# Access Compliance Report

## Public Rights-of-Way

### (Curb Ramps)

Intersection ID: 19165	Main Street: BEARMORE_DR	Cross Street: ROCKY_FALLS_RD	Location: NW
ADA ID: 4C35F832F289	Ramp Type: Perp	Initial Pass/Fail: Fail	Overall Compliance: No Severity Score: 21.25

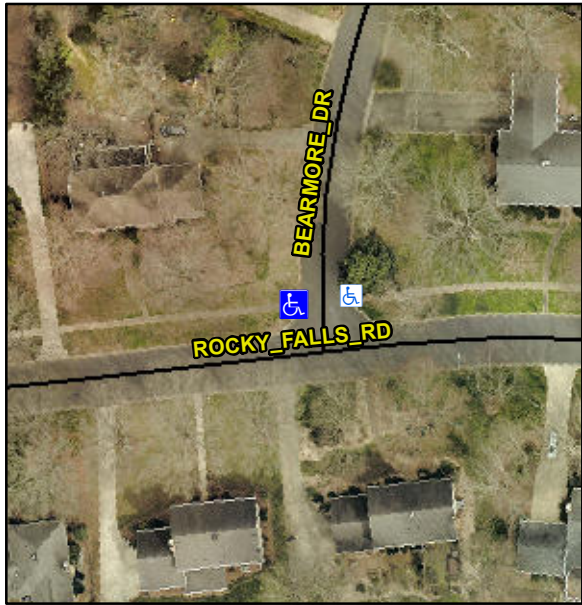
Codes/Mitigation Info/Possible Solution			Field Measurements/Component Compliance					
	Possible Solutions:		Compliance	Description	Data	Compliance	Description	Data
	Remove & Replace Entire Ramp.		N/A	Ramp Length (in)	74.0	No	Ramp Slope (%)	9.9
			No	Ramp Width (in)	47.0	Yes	Ramp XSlope (%)	1.9
			N/A	Flare Type LT	N/A	N/A	Flare Type RT	N/A
			N/A	Flare Slope LT (%)	N/A	N/A	Flare Slope RT (%)	N/A
			N/A	Flare Traversable LT?	N/A	N/A	Flare Traversable RT?	N/A
			N/A	Landing Length (in)	N/A	N/A	DWS Provided?	N/A
			N/A	Landing Width (in)	N/A	N/A	DWS Contrast?	N/A
			N/A	Landing Slope (%)	N/A	N/A	DWS Length (in)	N/A
			N/A	Landing X Slope (%)	N/A	N/A	DWS Full Width?	N/A
Surveyor Notes:			N/A	Landing Curb? (Y/N)	N/A	N/A	DWS Offset (in)	N/A
N/A			N/A	Shared Landing?	N/A			
PROW/ADA:			N/A	Gutter Ponding?	N/A	N/A	Gutter Slope (%)	N/A
Not Found, R304.5.1, R304.2.2			N/A	Gutter Lip Ht (in)	N/A	N/A	Gutter X Slope (%)	N/A

N/A	Painted X Walk1?	No	N/A	Painted X Walk2?	N/A
				X Walk 1 Direction	To E		X Walk 2 Direction	N/A
			N/A	X Walk 1 Width (in)	N/A	N/A	X Walk 2 Width (in)	N/A
				X Walk 1 Slope (%)	2.6		X Walk 2 Slope (%)	N/A
				X Walk 1 X Slope (%)	2.9		X Walk 2 X Slope (%)	N/A
			N/A	Ramp inside XWalk1?	N/A	N/A	Ramp inside XWalk2?	N/A
				Road Slope (%)	N/A	N/A	Clear Space?	N/A
				Road X Slope (%)	N/A	N/A	Clear Space to XWalk (in)	N/A
			N/A	Any Obstructions?	N/A	N/A	Storm Grate/Utility Hazard?	N/A
				Obstruction Type			Storm Grate/Utility Type	
					N/A			N/A
						Yes	Surface Condition? (G/P)	Good
